Item ID: D4634-141 Accept *N900040100* Setup Start *NS1*
 Revision ID: Stop *NS2*
 Item Name: Fwd, Center Ceiling Replacement Panel Assembly
 Start Date: 12/23/13 Start Qty: 1.00 *1* Cust Item ID:
 Required Date: 12/30/13 Req'd Qty: 1.00 *1* Customer:
 Reference:

WORK ORDER NON-CONFORMANCE / UPDATE

D4634-141 FWD. CENTER CEILING REPLACEMENT PANEL ASSY

DESIGN	RF	DART AEROSPACE LTD	
DRAWN	RF	HAWKESBURY, ONTARIO, CANADA	
CHECKED	BC	DRAWING NO.	REV. D
MFG. APPR.	BC	D4634	SHEET 7 OF 17
APPROVED	BC	TITLE	SCALE
DE APPR.	BC	CENTER CEILING PANELS	NTS
DATE	13.12.09	COPYRIGHT © 2012 BY DART AEROSPACE LTD THIS DOCUMENT IS PRIVATE AND CONFIDENTIAL AND IS SUPPLIED ON THE EXPRESS CONDITION THAT IT IS NOT TO BE USED FOR ANY PURPOSE OR COPIED OR COMMUNICATED TO ANY OTHER PERSON WITHOUT WRITTEN PERMISSION FROM DART AEROSPACE LTD.

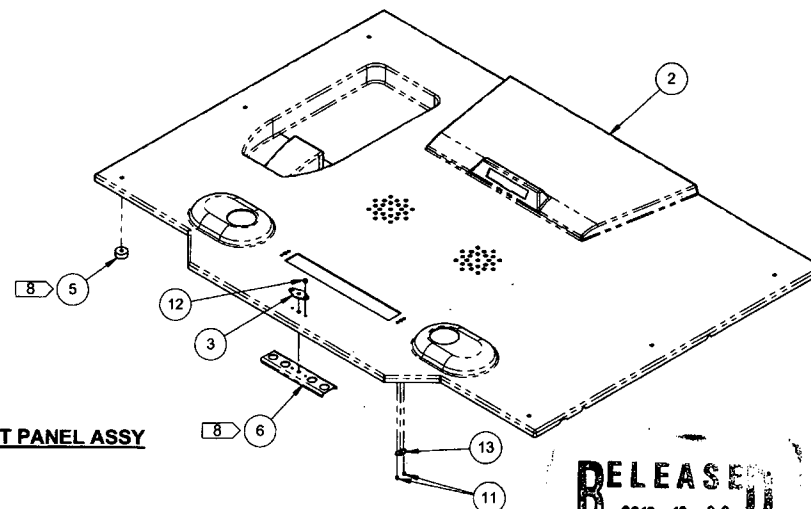
Root Cause	Date	Step	Qty	Description of work order update or non-conformance	Initial Chief Eng	Action Description	Sign & Date	Verification	QC Inspector
Design				Wrong D4712-1 Doubler.		Acceptable this time only. Per D.S. Attache's Email.			
Doc/Data				Was changed to the same/					
Equip/Tooling				employee used Rev B					
Handling/Pre				and not Rev C.					
Material			x1	RC employee pulled from		transfer Drill 0.125"			
Operator				stock older Rev parts prior		to deburr + touch.			
Offset/Setup	13/12/24	100		to any changes (Deming/ECN)	13/12/24	up to date as per Q2025	13/12/24	13/12/24	Q2042
Process				being released.	Per Attache's Email from David Shepherd				
Supplier									
Training									
Transport									
Unapproved

We have found our first little hiccup on the interiors this morning. Daryl pulled D4712-1 Rev B from stores and bonded it into place. On D4634-143 & D4334-141

The only changes I can see are the size of the holes. The rev b part have a 0.098" hole and the rev c has a 0.129" hole other than that I don't see any other changes in the two rev's.

To make it work the 0.098" holes will have to be transferred drilled, deburred, and touched up neatly with alodine as per QSI 005.

The reason for this was due to the rev B parts were still in stores and hadn't been pulled out let. Daryl had pulled his parts out of the stores department to get a jump on assembling the panels last week before any drawings ,ECN's were sent out.

Will this be acceptable?

This is acceptable.
